Re: Raymond-Ticen Ranch Winery, Major Modification to Use Permit,
Application # P15-00307-MOD

SUBJECT: Raymont-Ticen Winery – St. Helena, CA
Attended Noise Monitoring

Review of RAYMOND VINEYARD AND CELLAR, INC. / RAYMOND – TICEN RANCH WINERY MAJOR MODIFICATION TO USE PERMIT, APPLICATION #P15-00307 – MOD

ATTACHMENT B – Noise Measurement Locations

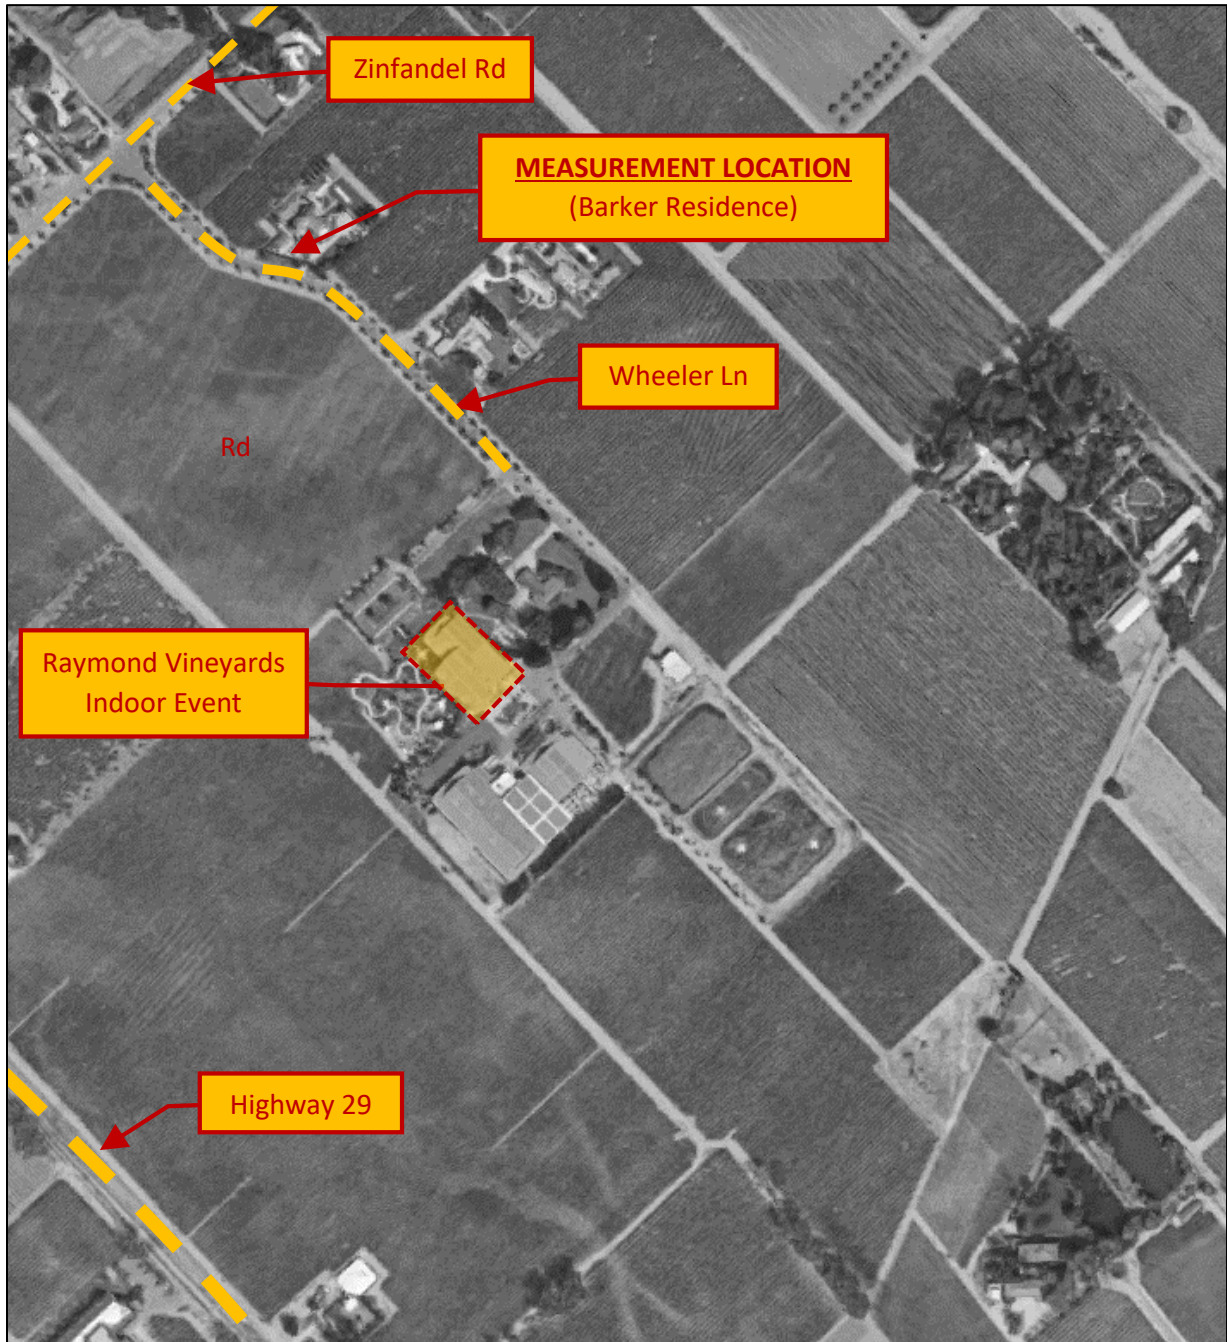
In summary, we observed an increase in traffic on Wheeler Lane during the event that exceeded the noise limit of 45 dBA by up to 3 dB at the Barker Residence (1500 Wheeler Lane). Event music was audible above the ambient noise at this location throughout the event until approximately 11:00 PM.

Photo 4: Cistern, willow and flow to the east, estimated at about 1 cfs.

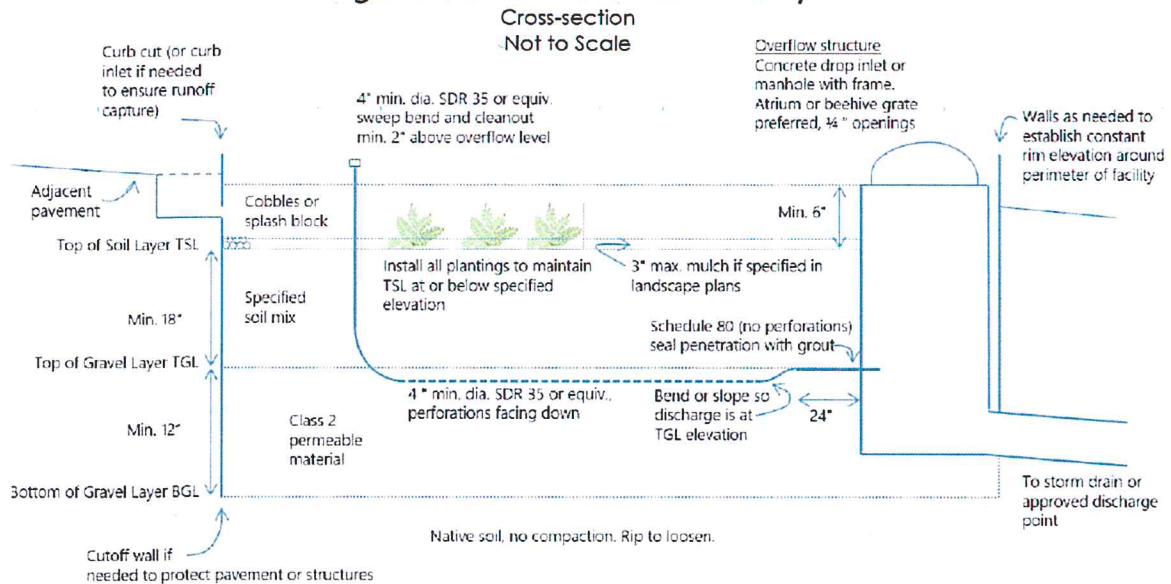
During the site visit, I observed several ditches ranging from 3 to 5 feet deep, as shown in Photo 5. These ditches would have water flowing in them. This water is either due to shallow drainage as described above or due to the discharge of drain tiles that underlie some of the vineyards. Drain tiles prevent deep drainage and are actually a manmade impediment to infiltration not discussed in the documents prepared for this application. The plans assume infiltration will occur in places where drain tiles could prevent it.
